Access Compliance Report

Public Rights-of-Way

(Curb Ramps)

Intersection ID: 10020400	Main Street: BALLANTYNE_GLEN_WY	Cross Street: N/A	Location: SW
ADA ID: BE7704B273B8	Ramp Type: Perp	Initial Pass/Fail: Fail	Overall Compliance: No
Severity Score: 33.75			
Codes/Mitigation Info/Possible Solution		Field Measurements/Component Compliance

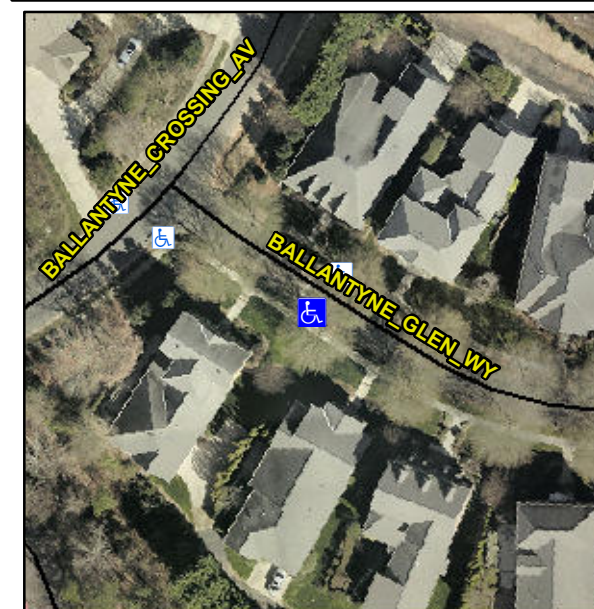
Not Found, R304.5.1, R304.2.2, R304.5.3

Compliance	Description	Data	Compliance	Description	Data
N/A	Ramp Length (in)	62.0	No	Ramp Slope (%)	9.5
No	Ramp Width (in)	47.5	No	Ramp XSlope (%)	5.8
N/A	Flare Type LT	N/A	N/A	Flare Type RT	N/A
N/A	Flare Slope LT (%)	N/A	N/A	Flare Slope RT (%)	N/A
N/A	Flare Traversable LT?	N/A	N/A	Flare Traversable RT?	N/A
N/A	Landing Length (in)	N/A	N/A	DWS Provided?	N/A
N/A	Landing Width (in)	N/A	N/A	DWS Contrast?	N/A
N/A	Landing Slope (%)	N/A	N/A	DWS Length (in)	N/A
N/A	Landing X Slope (%)	N/A	N/A	DWS Full Width?	N/A
N/A	Landing Curb? (Y/N)	N/A	N/A	DWS Offset (in)	N/A
N/A	Shared Landing?	N/A			
N/A	Gutter Ponding?	N/A	N/A	Gutter Slope (%)	N/A
N/A	Gutter Lip Ht (in)	N/A	N/A	Gutter X Slope (%)	N/A
N/A	Painted X Walk1?	No	N/A	Painted X Walk2?	N/A
	X Walk 1 Direction	To NE		X Walk 2 Direction	N/A
N/A	X Walk 1 Width (in)	N/A	N/A	X Walk 2 Width (in)	N/A
	X Walk 1 Slope (%)	1.3		X Walk 2 Slope (%)	N/A
	X Walk 1 X Slope (%)	6.7		X Walk 2 X Slope (%)	N/A

Remove & Replace Entire Ramp.
